Seismic Walkdown Checklist (SWC)

Equipment ID No.:	2MOV4516
Equipment Class:	(8) Motor-Operated and Solenoid-Operated Valves
Equipment Description:	21 SG FW ISOL

Seismic Walkdown Checklist (SWC)	N U
Equipment ID No.: 2MOV4517	
Equipment Class: (8) Motor-Operated and Solenoid-Operated Valves	
Equipment Description: 22 SG FW ISOL	
Project: CCNPP 2 SWEL	
Location (Bldg, Elev, Room/Area): AUX, 27.00 ft, CAL-AB-309	
Manufacturer/Model:	
Instructions for Completing Checklist This checklist may be used to document the results of the Seismic Walkdown of an item of equipment on the SWEL. The space below each of the following questions may be used to record the results of judgments and findings. Additional space is provided at the end of this checklist for documenting other comments.	
Anchorage	
 Is anchorage configuration verification required (i.e., is the item one of the 50% of SWEL items requiring such verification)? 	No

Equipment ID No.:	2MOV4517
Equipment Class:	(8) Motor-Operated and Solenoid-Operated Valves
Equipment Description:	22 SG FW ISOL

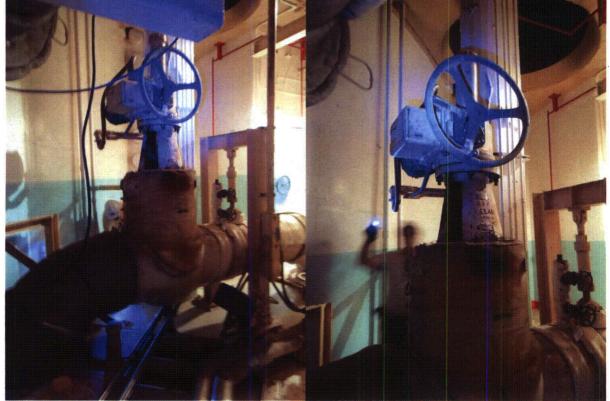
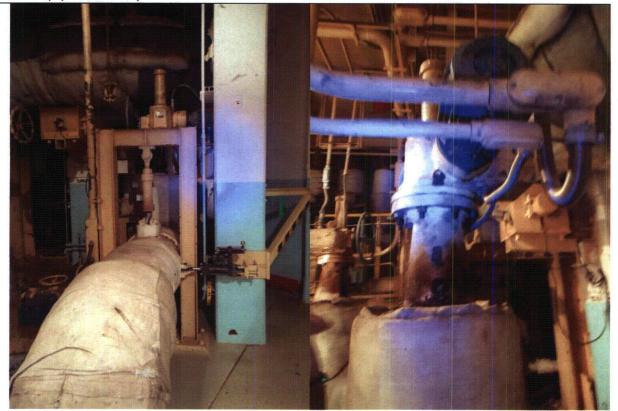
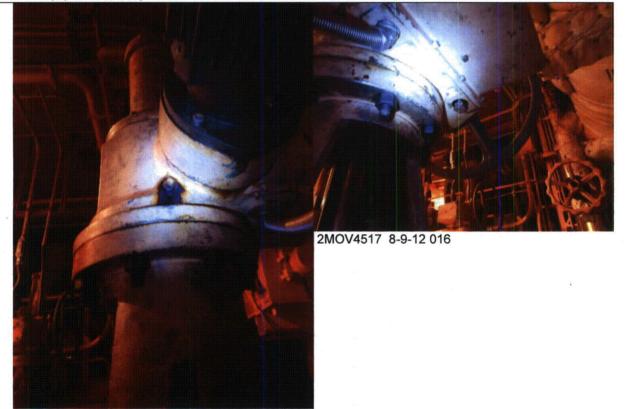
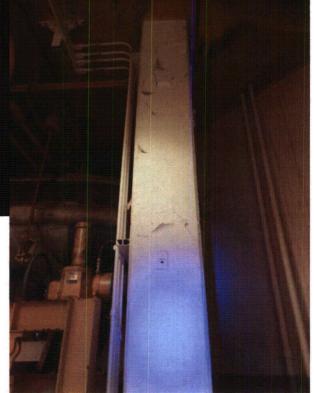
9. Do attached lines have adequate flexibility to avoid damage?	Yes
Flex conduit is connected to rigid conduit that is mounted to nearby concrete column. Flex conduit has adequate flexibility therefore not a seismic concern.

Equipment ID No.:	2MOV509
	(8) Motor-Operated and Solenoid-Operated Valves

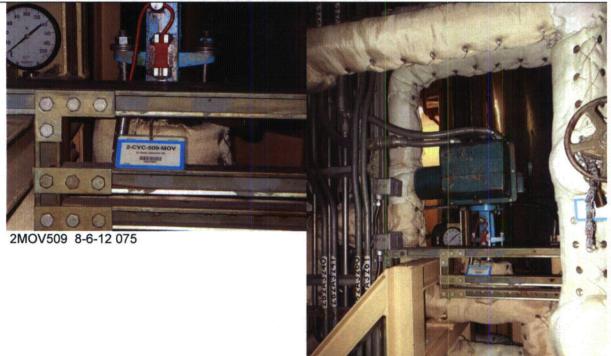
7. Are soft targets free from impact by nearby equipment or structures?	Yes
Operator is in close proximity to pipe, i.e. touching insulation. The pipe is part of valve's piping system, therefore minimal differential motion expected. Judged not a seismic concern. Also, a unistrut frame is touching the top of a horizontal valve component, the condition may cause some scrapping, but judged not a seismic concern.

Equipment ID No.:	2MOV514	
	Equipment Class:	(8) Motor-Operated and Solenoid-Operated Valves
Ed	uipment Description:	BAPP'S TO CHG PP SUCT DIR

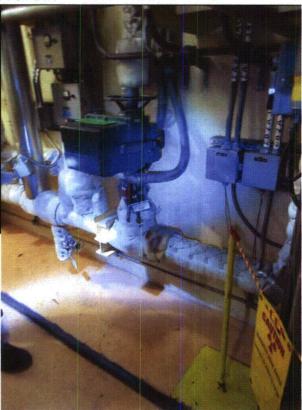
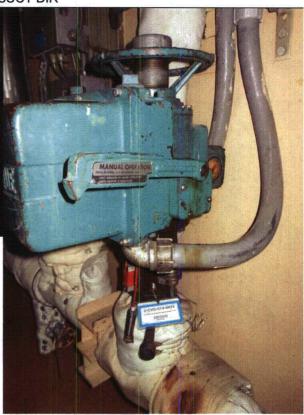
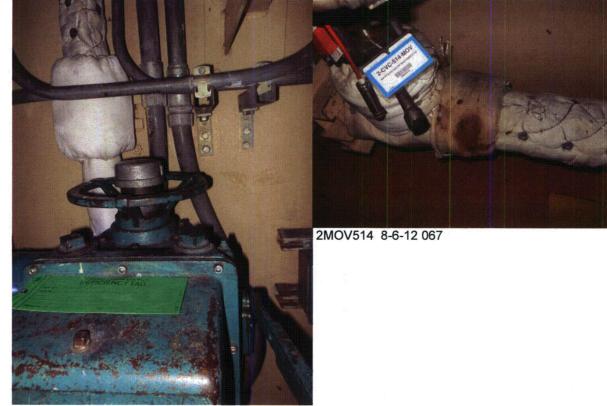
11.	Have you looked for and found no adverse seismic conditions that could adversely affect the safety functions of the equipment? The pipe is laterally supported near the valve, judged not to be a concern.	Yes
Comm	nents	_
Evalua	A. Karavoussianis Date: 11/09/2012

Equipment ID No .:	2MOV615
Equipment Class:	(8) Motor-Operated and Solenoid-Operated Valves
Equipment Description:	21B LPSI OUTLET MOV

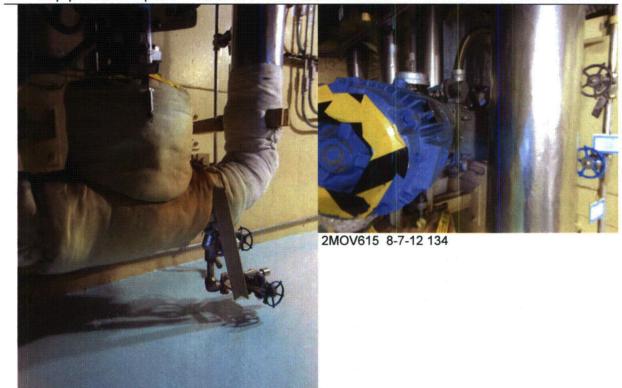
7. Are soft targets free from impact by nearby equipment or structures?	Yes
8. Are overhead equipment, distribution systems, ceiling tiles and lighting, and masonry block walls not likely to collapse onto the equipment? Valve's hand wheel is approximately 1" from flexible hose, judged not a seismic concern.	Yes

Equipment ID No.:	2MOV627
Equipment Class:	(8) Motor-Operated and Solenoid-Operated Valves
Equipment Description:	21A AUX HPSI LOOP ISOL

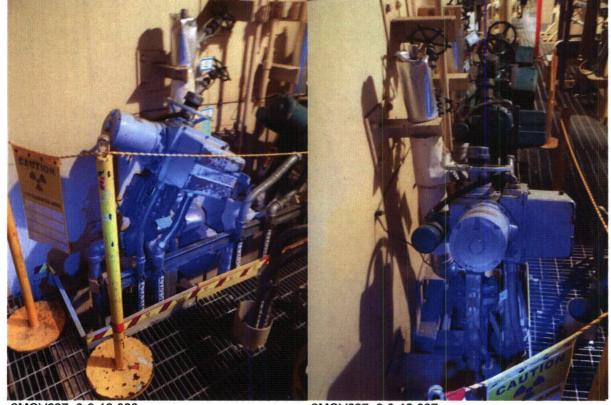
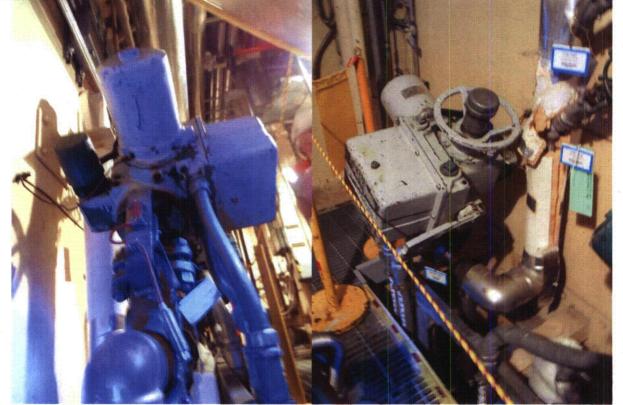
8. Are overhead equipment, distribution systems, ceiling tiles and lighting, and masonry block walls not likely to collapse onto the equipment? Nearby scaffold is adequately braced and does not pose a seismic hazard.		Yes

9. Do attached lines have adequate flexibility to avoid damage? There is flex conduit from the operator connected to rigid conduit that is		Yes
 supported on a nearby frame, judged to have adequate flexibility. 10. Based on the above seismic interaction evaluations, is equipment free of potentially adverse seismic interaction effects? 		Yes
Other Adverse Conditions 11. Have you looked for and found no adverse seismic conditions that could adversely affect the safety functions of the equipment? Ye		
<u>Comments</u>		
Evaluated by: A. Karavoussianis Date:	11/09/2012

Seismic Walkdown Checklist (SWC)				
Equipment ID No.:	2PCV3939A			
Equipment Class:	(0) Other			
Equipment Description:	2I/P3939 IA SUPPLY

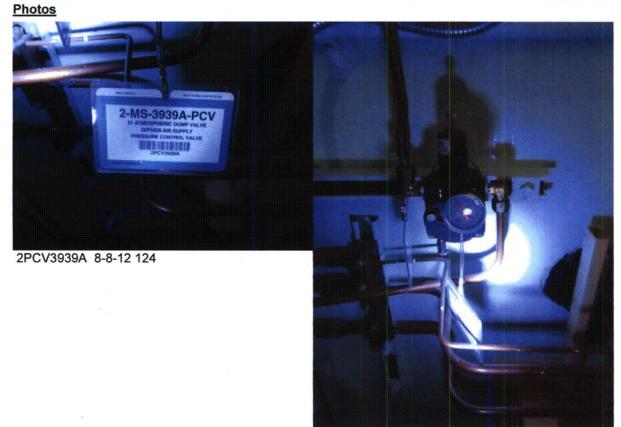
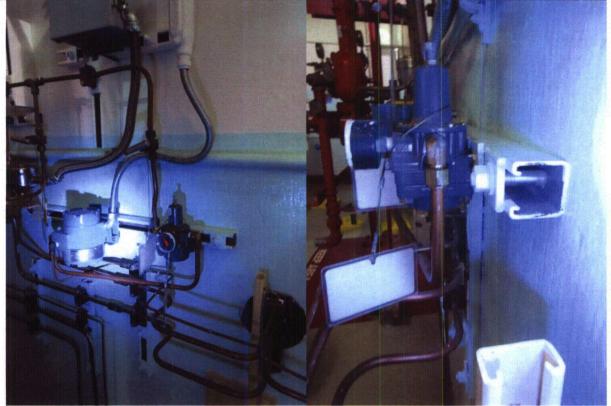
4. Is the anchorage free of visible cracks in the concrete near the anchors?	Yes
5. Is the anchorage configuration consistent with plant documentation? (Note: This question only applies if the item is one of the 50% for which an anchorage configuration verification is required.) PCV is bolted to unistrut by 2-7/16 F-F bolts head (i.e. 3/8" bolt). Unistrut mounted to wall by 2-1/2" CEA. Need plant documentation to determine if anchorage is consistent with as-built	No
sketch. CR-2012-009779

Seismic Walkdown Checklist (SWC)	Status: Y N U
Equipment ID No.: 2PCV3939A	
Equipment Class: (0) Other	
Equipment Description: 2I/P3939 IA SUPPLY	
Need plant documentation to determine if anchorage is consistent with as- built sketch.	
Interaction Effects

Equipment ID No.:	2PNL2C08
Equipment Class:	(20) Instrumentation and Control Panels and Cabinets
Equipment Description:	ENGINEERING SAFEGUARDS CONTROL

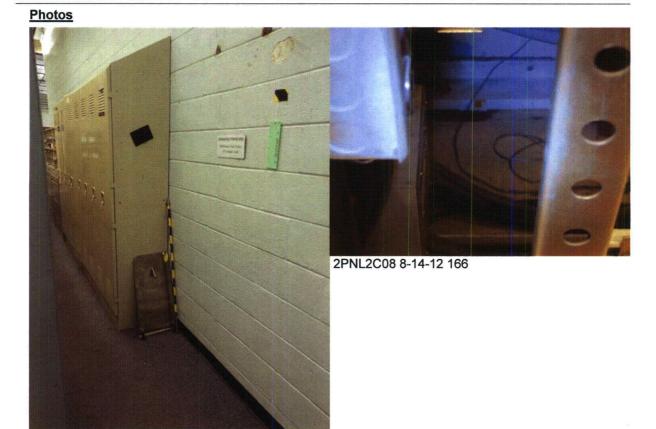
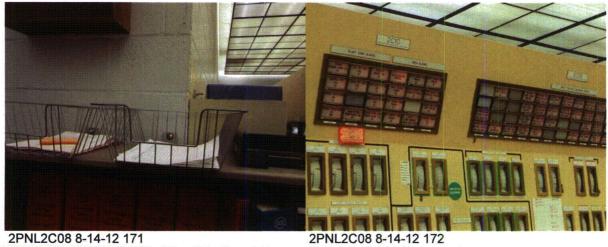
5.	This question only ap configuration verificat Anchorage used det	iguration consistent with plant documentation? (Note: olies if the item is one of the 50% for which an anchorage on is required.) ails that are not shown on the drawing, but are judged to s-built on drawing G1992 SH0004 Rev. 9. CR-2012-	No

8. Are overhead equipment, distribution systems, ceiling tiles and lighting, and masonry block walls not likely to collapse onto the equipment? Yes Observed a drop ceiling and light diffuser ceiling. 10/3/12 - The control room ceiling has been previously evaluated by CCNPP and was determined to not be a credible seismic concern. Yes Observed a masonry block wall behind the panels. The block wall, identified as AA on drawing A-259, is safety-related and thus seismically rated per IE Bulletin 80-11. Yes 9. Do attached lines have adequate flexibility to avoid damage? Yes 10. Based on the above seismic interaction evaluations, is equipment free of potentially adverse seismic interaction effects? Yes 11. Have you looked for and found no adverse seismic conditions that could adversely affect the safety functions of the equipment? Yes Evaluated by: A. Marmannin A. Karavoussianis Date: 11/09/2012 Mathum. A. Karavoussianis Date: 11/09/2012	Interaction Effects

as AA on drawing A-259, is safety-related and thus seismically rated per IE Bulletin 80-11. 9. Do attached lines have adequate flexibility to avoid damage? Yes 10. Based on the above seismic interaction evaluations, is equipment free of potentially adverse seismic interaction effects? Yes <u>Other Adverse Conditions</u> 11. Have you looked for and found no adverse seismic conditions that could adversely affect the safety functions of the equipment? Yes <u>Comments</u> Evaluated by: <u>A. Karavoussianis</u> Date: <u>11/09/2012</u>	masonry block walls not likely to collapse onto the equipment? Observed a drop ceiling and light diffuser ceiling. 10/3/12 - The control room ceiling has been previously evaluated by CCNPP	Yes
potentially adverse seismic interaction effects? Other Adverse Conditions 11. Have you looked for and found no adverse seismic conditions that could adversely affect the safety functions of the equipment? Comments Evaluated by: A. Karavoussianis Date: 11/09/2012	as AA on drawing A-259, is safety-related and thus seismically rated per IE Bulletin 80-11.	Yes

Equipment ID No.:	2PNL2C09
Equipment Class:	(20) Instrumentation and Control Panels and Cabinets
Equipment Description:	ENGINEERING SAFEGUARDS CONTROL

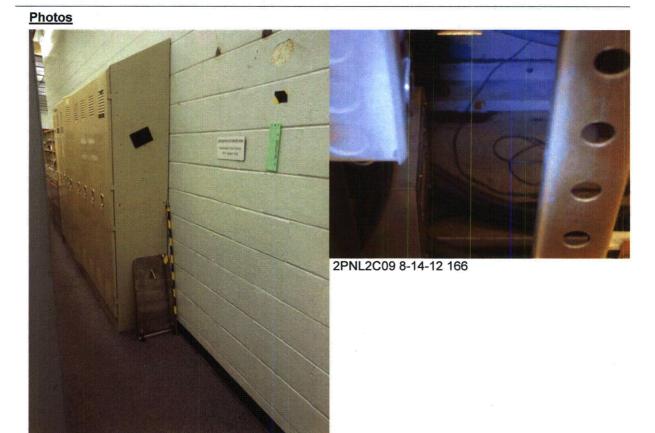
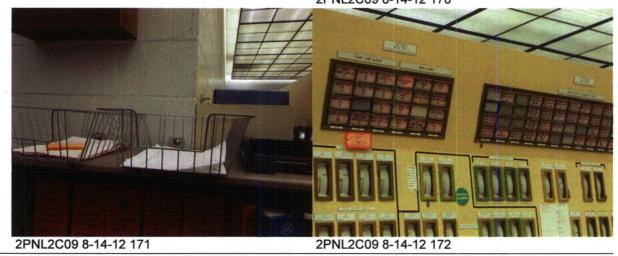
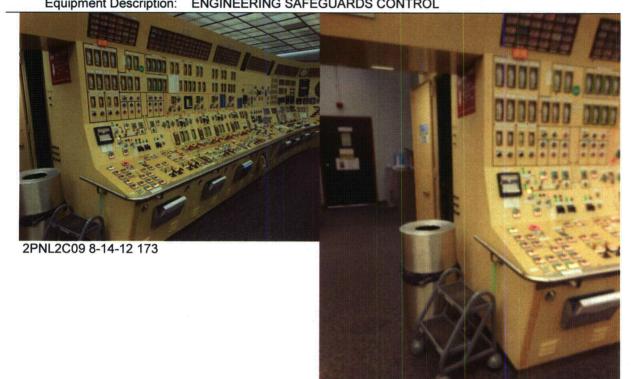
7. Are soft targets free from impact by nearby equipment or structures?	Yes
 Are overhead equipment, distribution systems, ceiling tiles and lighting, and masonry block walls not likely to collapse onto the equipment? Observed a drop ceiling and light diffuser ceiling. 10/3/12 - The control room ceiling has been previously evaluated by CCNPP 	Yes
and was determined to not be a credible seismic concern. Observed a masonry block wall behind the panels. The block wall, identified as AA on drawing A-259, is safety-related and thus seismically rated per IE Bulletin 80-11.

Equipment ID No.:	2PNL2D11
Equipment Class:	(2) Low Voltage Switchgear
Equipment Description:	125VDC PNL DC21 2D11
2PNL2D11 8-14-12 039	2PNL2D11 8-14-12 040

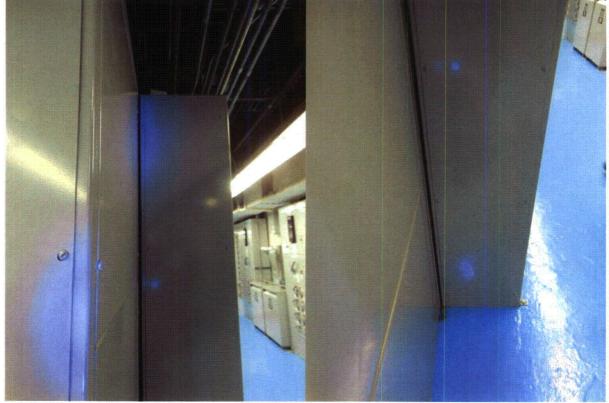
4. Is the anchorage free of visible cracks in the concrete near the anchors?	No
Anchorage is inaccessible.	
5. Is the anchorage configuration consistent with plant documentation? (Note: This question only applies if the item is one of the 50% for which an anchorage configuration verification is required.) Anchorage is inaccessible.	No

14.5"D x 84"W x 90" High. Evaluated using 8 Hz frequency for cabinets 2% Damping Ratio, 1.5 PF Response Spectrum AB027D2N.dat A=0.25g D= 2 * (1.5*0.25*386) / (8x2x3.14)^2 = 0.11" < 3/8" OK 8. Are overhead equipment, distribution systems, ceiling tiles and lighting, and masonry block walls not likely to collapse onto the equipment? There are block walls nearby. Masonry block walls, identified as T, S, N, AA and BB on drawing A-260, are safety-related and thus seismically rated per IE Bulletin 80-11. 9. Do attached lines have adequate flexibility to avoid damage? 	
 D= 2 * (1.5*0.25*386) / (8x2x3.14)^2 = 0.11" < 3/8" OK 8. Are overhead equipment, distribution systems, ceiling tiles and lighting, and masonry block walls not likely to collapse onto the equipment? There are block walls nearby. Masonry block walls, identified as T, S, N, AA and BB on drawing A-260, are safety-related and thus seismically rated per IE Bulletin 80-11. 9. Do attached lines have adequate flexibility to avoid damage? 10. Based on the above seismic interaction evaluations, is equipment free of

Are overhead equipment, distribution systems, ceiling tiles and lighting, and masonry block walls not likely to collapse onto the equipment? There are block walls nearby. Masonry block walls, identified as T, S, N, AA and BB on drawing A-260, are safety-related and thus seismically rated per IE Bulletin 80-11. Do attached lines have adequate flexibility to avoid damage? 10. Based on the above seismic interaction evaluations, is equipment free of
